Pennsylvania Department of Environmental Protection
Response to
Clean Air Task Force Report: “Impacts On Water Quality From
Placement Of Coal Combustion Waste In Pennsylvania Coal Mines”

DEP Bureau of Mining and Reclamation
DEP Bureau of District Mining Operations

November 9, 2007

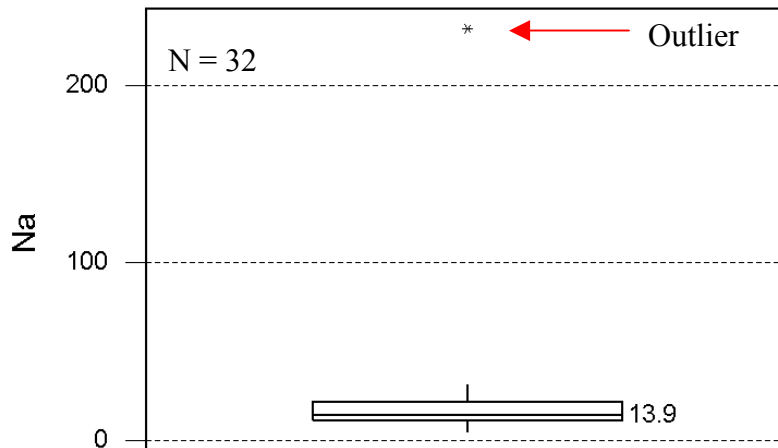
CATF gives undue weight to outlier data. Outliers are data points that are numerically distant from typical values. Fortunately they are infrequent events. Most large sets of water quality data contain outliers. CATF routinely assumes that outliers identify pollution events; this is an invalid assumption. Outliers occur for a lot of reasons including improper sample collection, errors in sample analysis, switching of samples (sample was collected somewhere else), reporting error (such as a decimal error or multiplication by 10), and inclusion of large quantities of suspended matter during sample collection. Typically, outliers are visually obvious, but if they are not evident, there are statistical approaches that can identify outliers (see Figure 2). Another flaw in the logic of citing individual sample events as evidence of degradation is that one must then be equally willing to declare the sampling point improved when the very next sampling event reveals lower concentrations, yet such conclusions are not found in the CATF report. From the Department's experience with mine sites, when pollution events occur they (unfortunately) persist. Pollution at mines is not a one time or infrequent event, but a continuing trend.

Figure 3. Example of one outlier (8/1999) skewing the trend line that is generally flat. There is also an outlier in the pre-ash placement data, which is higher than any post-ash placement value. (Fig. 4.10 from CATF report)

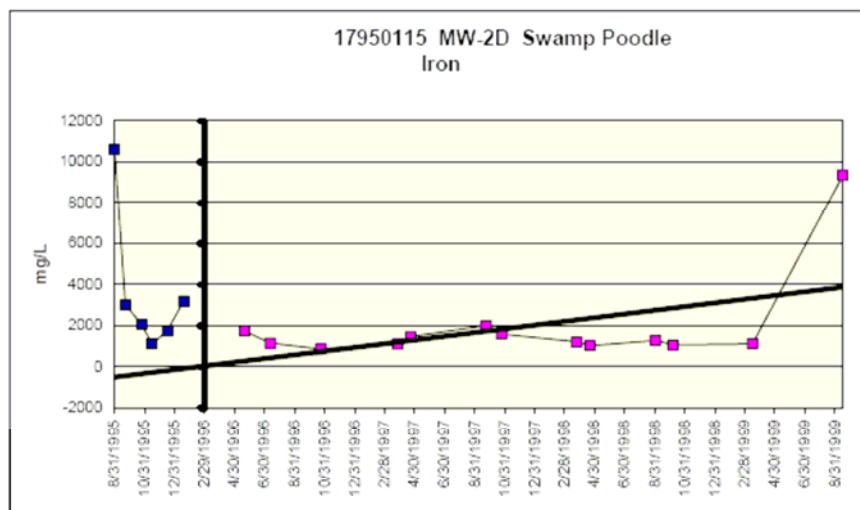
CATF uses statistical trend lines inappropriately. Trend lines are used throughout the report to imply cause-and-effect relationships that often are not otherwise demonstrated nor discussed. Additionally, two CATF interpretation errors are frequently made: (a) Trend lines are placed through data that contains one or two outliers (See example of this in Figure 3). These outlier values, more likely than not being spurious data, are frequently the result of sample collection or analytical error. Placing trend lines through these types of data give outliers undue weight. (b) Trend lines are placed through data that fluctuate widely (Figure 4). These fluctuations are common with mine-impacted waters and are due to seasonal variations and individual precipitation events. Wet times of the year will often result in mine drainage with low concentrations of chemical parameters, or conversely, if a rain event follows a period of drought concentrations can be elevated due to flushing of accumulated pyrite weathering products.

Figure 6. A plot of lead concentration through time at the Ernest site.

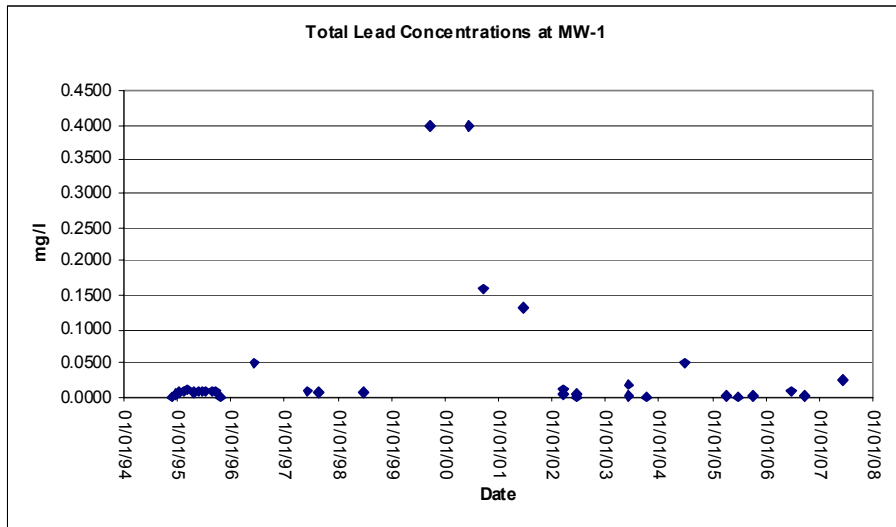
An example of how the CATF and the Department look at the same data and reach different conclusions is illustrated by considering total lead concentrations at monitoring well MW-1 at the Ernest site. On page 57 of its report CATF includes several statements that imply a significant increase in lead at MW-1 over time and state that it "may" be due to ash. On page 65 of the report this alleged increase is characterized as "degradation." The available lead data from MW-1 are graphed in Figure 6. The Department's conclusions regarding the data in Figure 1 include: 1) the abandoned coal refuse at the Ernest site is capable of leaching detectable levels of lead based on the pre-remining (pre-October 1996) data; 2) the high detection limits of 0.40 mg/l reported by the company in the 9-23-99 and 6-16-00 results and of 0.05 mg/l on 6-12-96 and 6-29-04 may not be appropriate, but do not represent actual lead levels; 3) there are detect-

able lead concentrations scattered through the data set; 4) there is no discernible trend in the data that can be accurately characterized as a trend or “degradation.”

Figure 6. Chloride values appear to have increased but values are still far below drinking water secondary MCL values of 250 mg/l. (Figure 5.22a from CATF report)

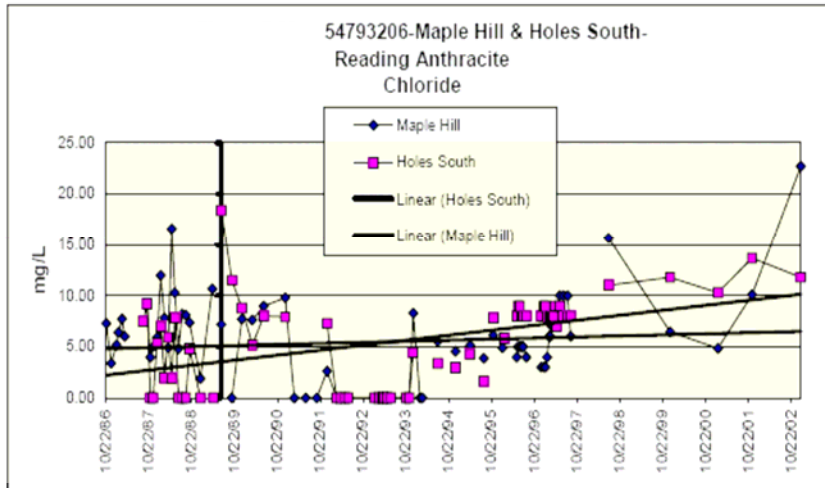
The CATF overemphasizes that parameter 'a' increased 'x' times when in fact the data show concentrations for the element are still quite low. For example, sodium and calcium at Maple Hill & Holes South site (Figure 6) increased over time but remained well below levels routinely consumed in food and drink. There was an increase, but it is inconsequential.

Figure 8. One value causes a clear misrepresentation of a trend. The post-ash data fall mostly below the trend line. Again, the concentrations are inconsequentially low. (Fig. 6.13 from CATF report).

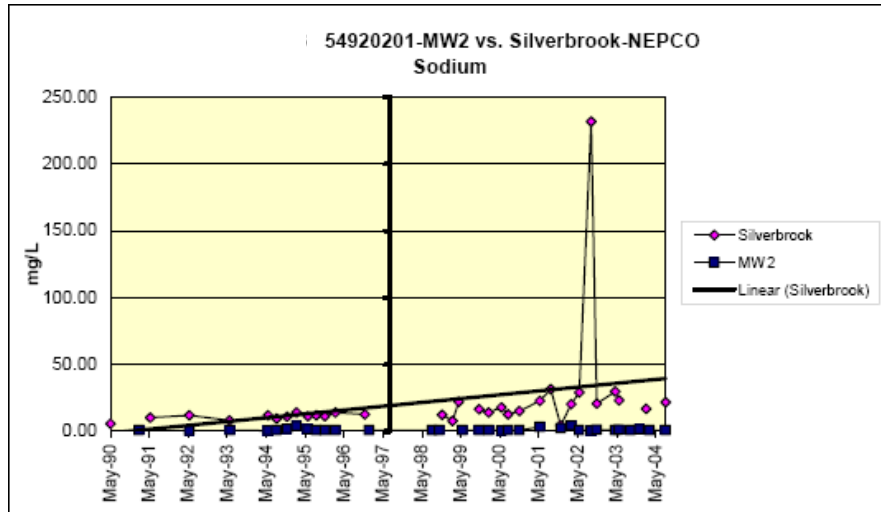
The CATF report contains inappropriate trend lines that project into the past or future where there is no data. Obviously, this is a misleading practice. In the sodium graph, the trend line is highly skewed by one errant sample and becomes a clearly false representation of the data since most of the measured values are contained below it (Figure 8). This errant point is an excellent example of a statistical outlier.

Figure 9. The trend line does not realistically represent the behavior of the data. (Fig. 9.3A from CATF report)

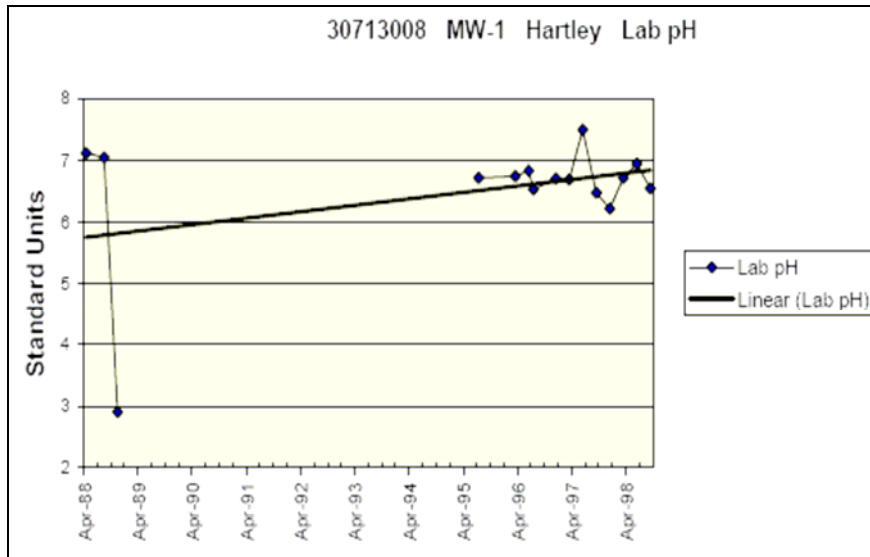
The CATF report does not hesitate to use a lack of data to draw hard conclusions where no data exists. Trend lines are drawn and conclusions are made even though there are wide variations in data or missing data points (see Figure 9). The CATF does not hesitate to use outliers to see problems. The CATF has built its arguments for pollution by making unsupported assumptions and theorized hydrologic connections.

Figure 10. This graph could be interpreted as being three separate parameters increasing through time. However, they essentially measure the same property of the water. (Figure 10.51 of CATF report)

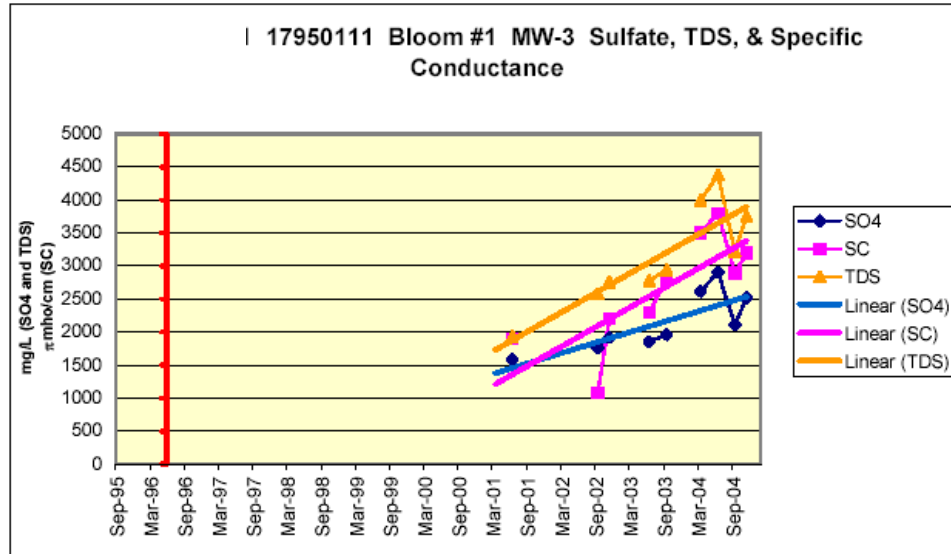
MW-3 is a monitoring well drilled into the backfill of the mine site down to the Middle Kittanning coal seam. The bottom of the well is located 5 feet below the pit floor. The well is cased through the spoil and fly ash so that samples of groundwater within the spoil can be collected. Only one sample has been collected from this monitoring point that included the ash parameters. The elevated parameters are most likely due to high suspended solids within the sample (418 mg/L). High suspended solids at this sample point has been a routine problem at this monitoring point with other samples (samples collected for mine drainage parameters) having 89 mg/L suspended solids or higher for every sample. The data show increasing alkalinity and decreasing acidity, which is attributed to the ash. The elevated sulfate is probably attributable to both the mining and ash placement. Figure 9 shows the increase in sulfate. For those who are unfamiliar with water chemistry, this graph is deceptive: all three parameters plotted on the graph essentially depict the same thing and should look the same. Sulfate is a dominant anion and its concentration would be directly related to total dissolved solids (TDS). Specific conductivity (SC) is simply a way to estimate TDS using an electrode. All three measure the same property.

Elevated concentrations of many constituents are probably due to suspended matter that entered the water during collection and not due to dissolved ions in the water. More samples and filtered samples would resolve the issue of the source of elevated ions.

Figure 11. Chloride and sodium concentrations before and after ash placement. Note that pre-placement values are as high or higher than post-ash placement. All concentrations are low and inconsequential. (Figure 11.11A of CATF report).

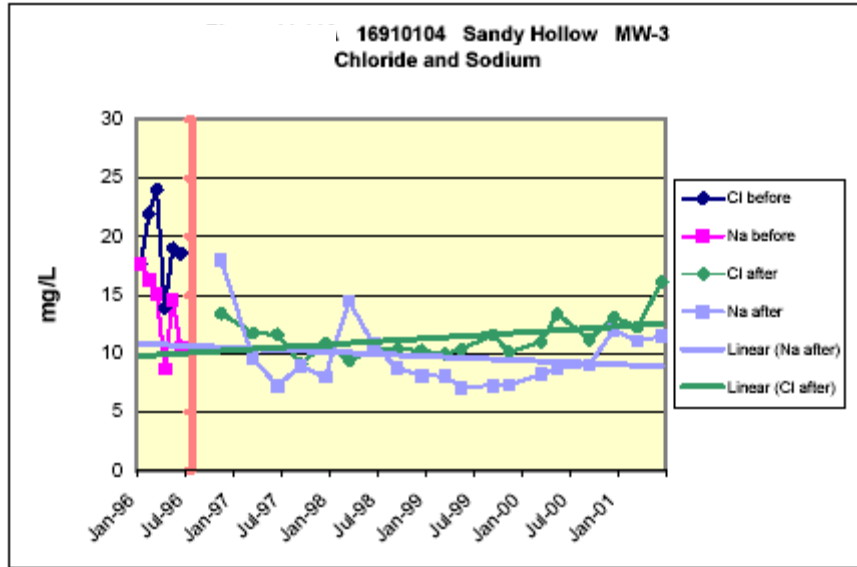
Monitoring data shows that there was an increase in mining-related groundwater parameters that, with the exception of sulfate, returned to pre-mining levels. Chloride and sodium are indicator parameters for FBC ash. The flat lying trend with these parameters (Figure 11) does indicate that there has been no degradation as a result of ash placement on the Sandy Hollow site.
